**Mountain Valley Pipeline, LLC  
Mountain Valley Pipeline Project  
Docket No. CP16-10-000**

**Responses to Environmental Information Request  
Dated December 24, 2015**

**Federal Energy Regulatory Commission**

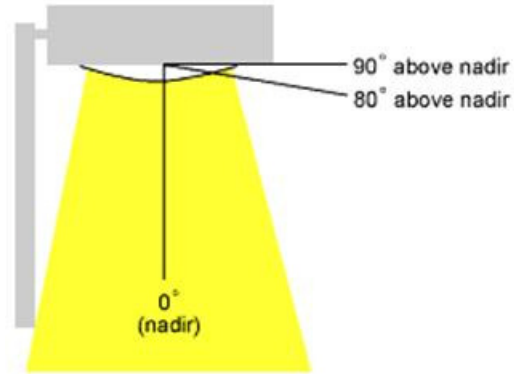
- b. Artificial lighting from aboveground facilities can contribute to ecological light pollution (the alterations of the natural periods of light and dark) resulting in a wide-range of impacts to wildlife (Longcore and Rich 2004). Exposure to artificial nocturnal light can provide false cues related to photoperiod and has the potential to affect navigation, reproduction, and other behaviors of wildlife.

The Illuminating Engineering Society of North America (IESNA) defines several outdoor luminaire cutoff classifications, each with different photometric criteria. For these classifications, two relevant zones are defined with respect to the nadir of a luminaire (the nadir is defined as the angle that points directly downward, or 0°, from the luminaire). One zone applies to angles at or above 80° above nadir, and the second zone covers all angles at or above 90° above nadir, or above the horizontal plane of the luminaire. Light emitted in the 80° to 90° zone is more likely to contribute to glare, and light emitted above the horizontal is more likely to contribute to sky glow. The four IESNA classifications are defined as follows (IESNA 2000):

- Full cutoff—The luminous intensity (in candelas) at or above an angle of 90° above nadir is zero, and the luminous intensity (in candelas) at or above a vertical angle of 80° above nadir does not numerically exceed 10% of the luminous flux (in lumens) of the lamp or lamps in the luminaire.

Fully shielded but not a “full cut-off”

Fully shield AND also “full cut-off”

“Full cut-off” lighting provides the maximum possible shielding to prevent unintentional lighting of surrounding areas.
